Stakeholder Comments Template

Resource Adequacy Revised Straw Proposal

Submitted by	Organization	Date Submitted
Brian Theaker 530-259-3305	NRG Energy, Inc.	July 24, 2019

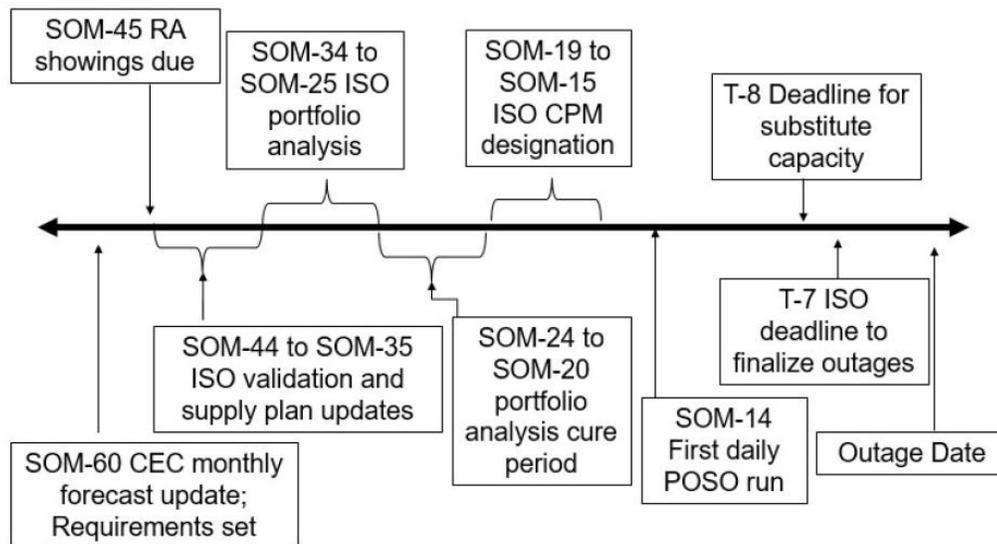
The CAISO’s proposed new planned outage process timeline is as follows:

NRG notes that this proposed process provides only six days for the generator owner, once notified of a substitution obligation from the POSO process, to provide substitute capacity or, likely have its planned outage, which it may have submitted months in advance, cancelled.
